TO: Mercedes-Benz Principals, General Managers, Sales Managers, Service Managers, Parts Managers	FROM: Anthony Washington, Department Manager, Regulations and Certifications
<b>Re: Recall Campaign Launch Notification Models 907 (Sprinter) Model Years 2019-2020 Remove Power Sliding Door Function</b>	DATE: December, 2022

SUBJECT: **Model 907 Sprinter, Model Year 2019-2020**  
**Remove Power Sliding Door Function**

**Sliding door conversion (code: VS3SCHIEBT, acc. no.: 72 951 62)**

D72.16-A049-76

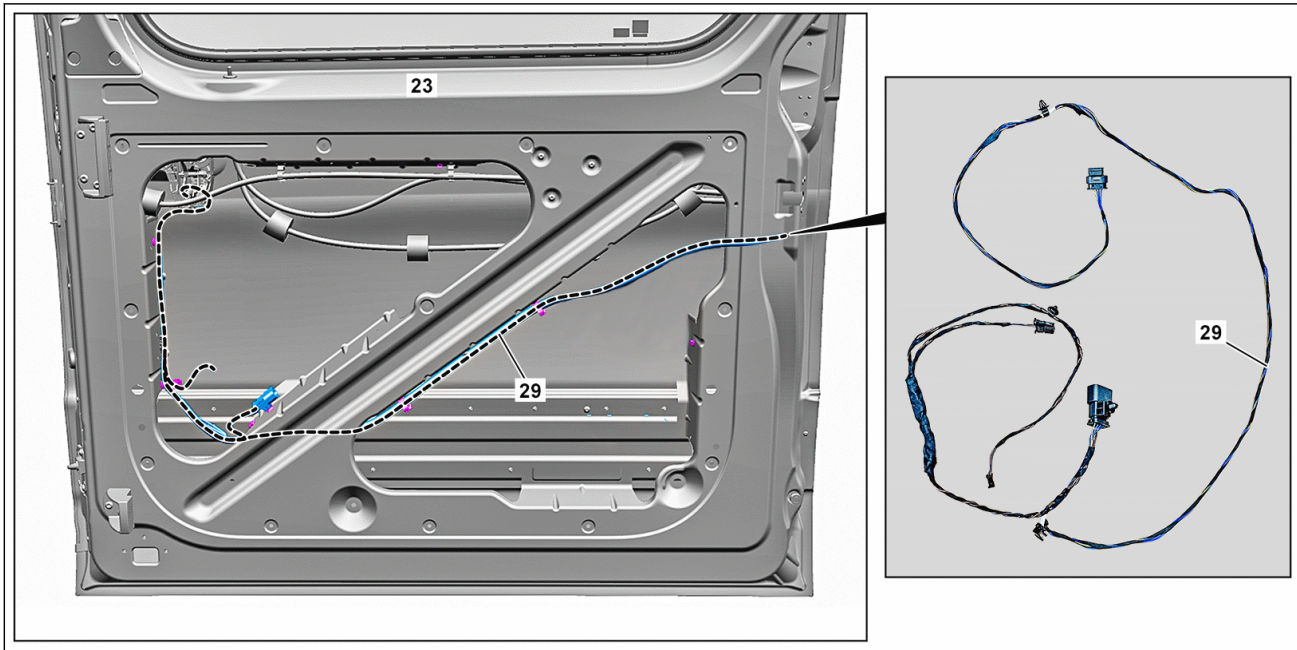
- 1 Remove electrical wiring harness (28).

To do so, unclip electrical wiring harness (28) from sliding door (23).

The electrical wiring harness (28) is no longer required.

D72.16-A050-79

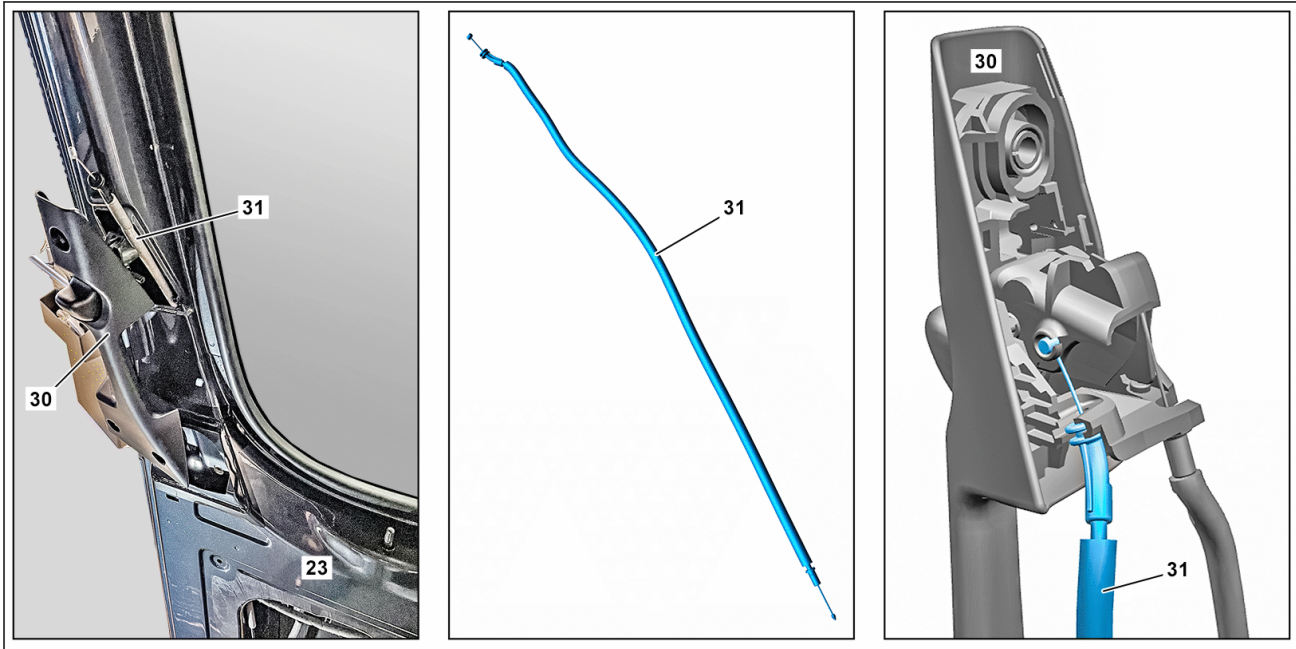
- 2 Install new electrical wiring harness (29) as shown.

Order part number for electrical wiring harness (29) according to list below.

D72.16-A054-79

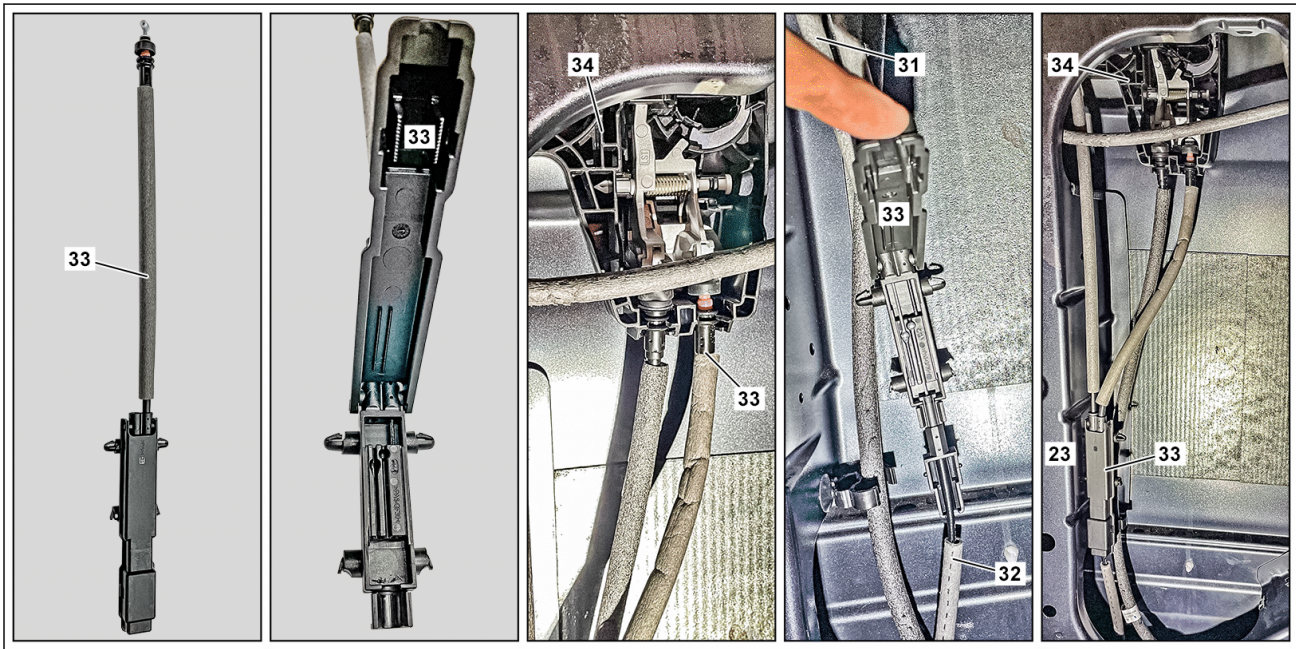
- 3 Route cable (31) through sliding door (23) to door handle (30).  
 ⚠ Handle cables carefully and do not kink them.  
 Damage may occur otherwise.

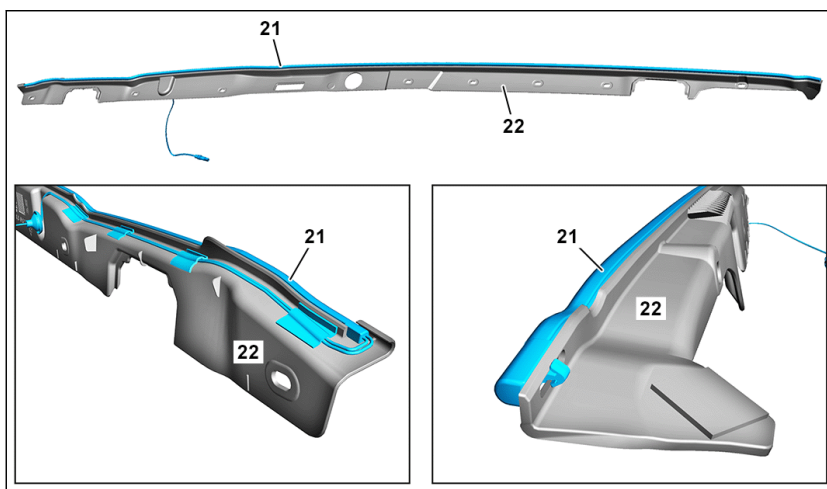
- 9 Remove anti-entrapment strip (21) from trim (22).

To do so, remove anti-entrapment strip (21) using  clip remover then remove adhesive tape.

The anti-entrapment strip (21) is no longer required.

D72.16-A053-73

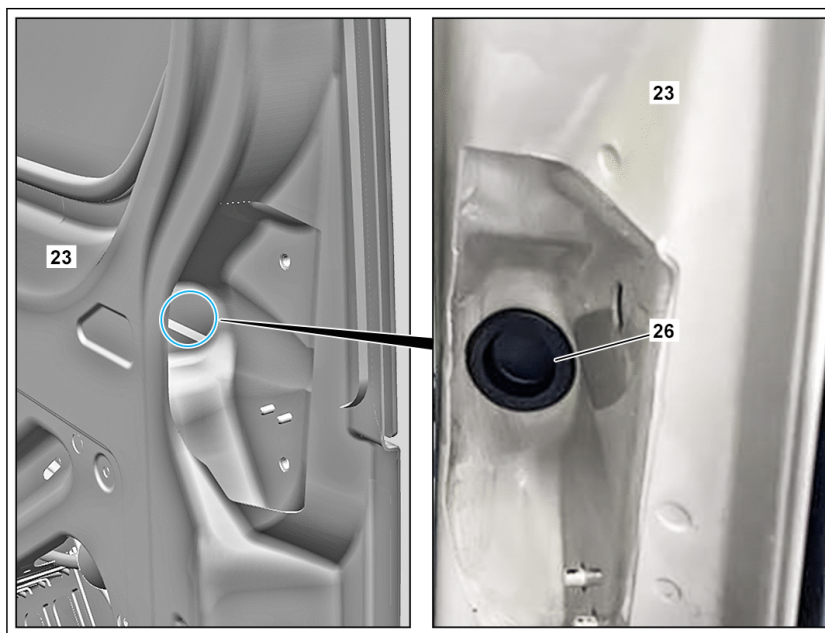
- 12 Clean contact surface of stop plug (26).

- 13 Install stop plug (26) into opening of sliding door (23).

D72.16-A078-82

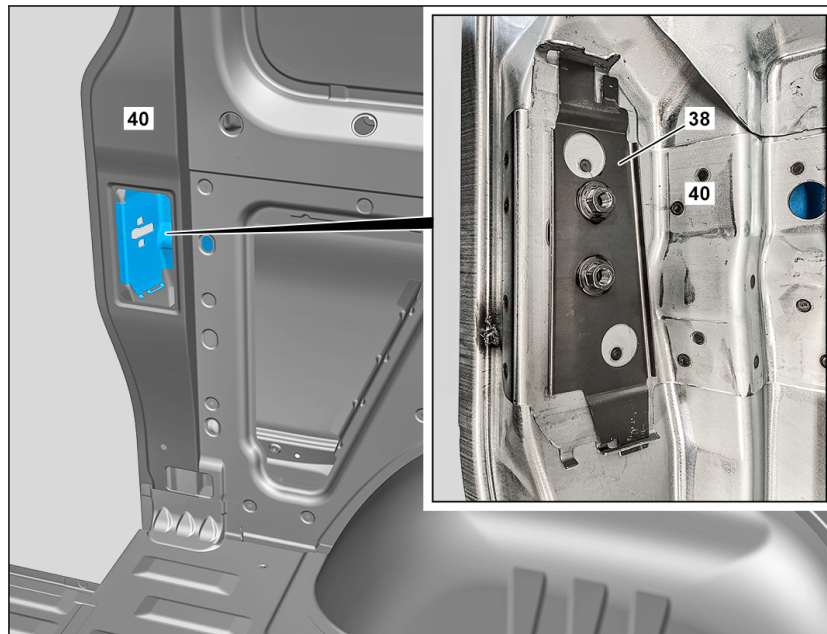
- 2 Install reinforcement (38) on C-pillar (40).

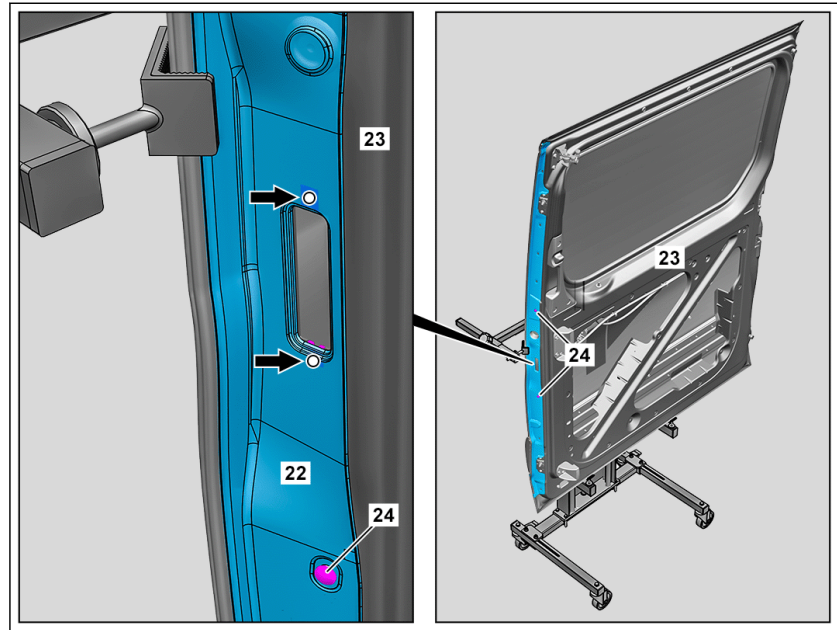
- 17 Drill holes (arrows) with  $\varnothing$  5 mm on trim (22).

The holes (arrows) must line up with those in the sliding door (23).

D72.16-A076-76

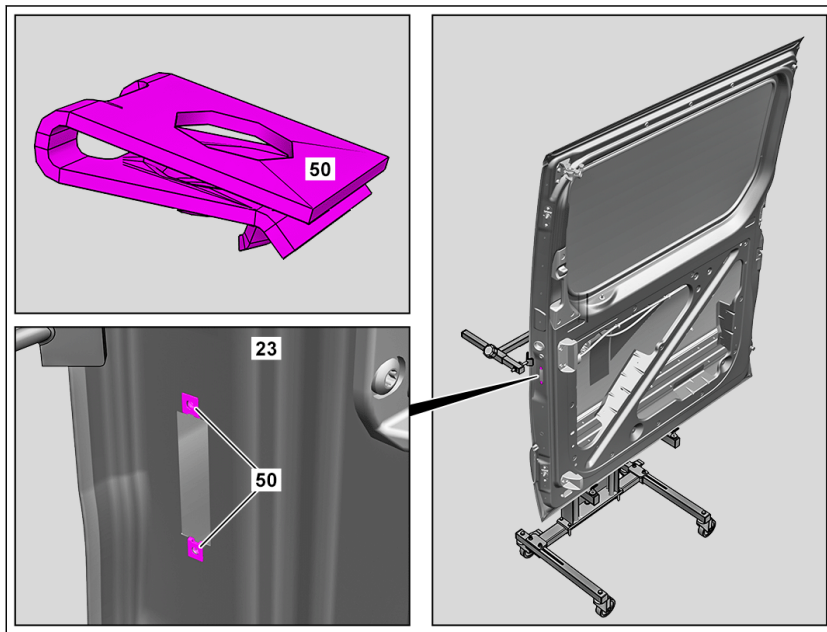
- 20 Attach spring lock nuts (50).

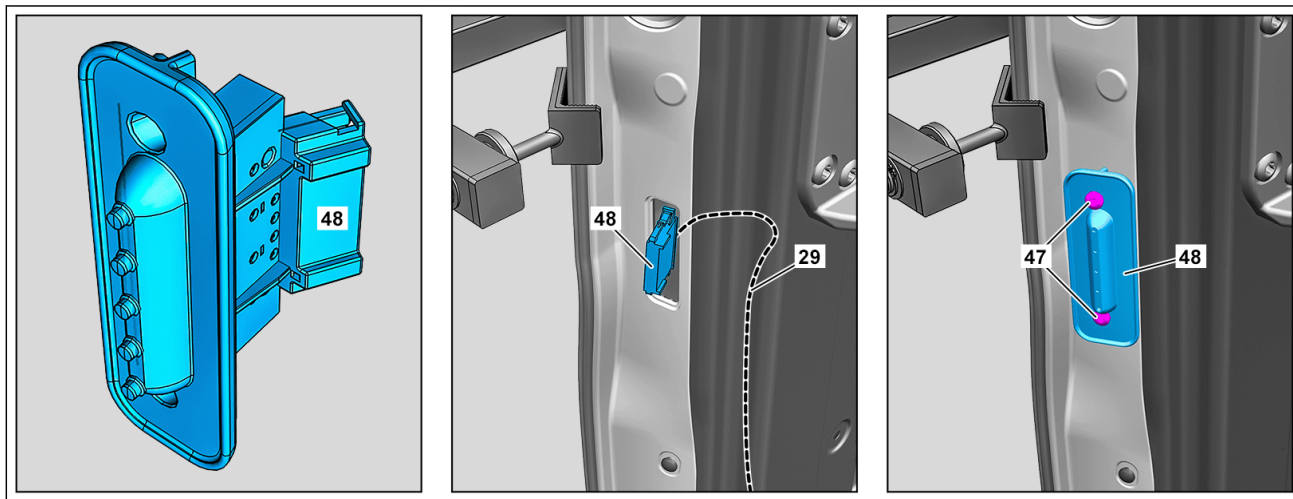
- 3 Remove lower carriage (42) from sliding door.

- 4 Release cable duct (44) (arrow) and remove from lower sliding carriage (42).

- 5 Remove cable duct (44) with electrical wiring harness (45).
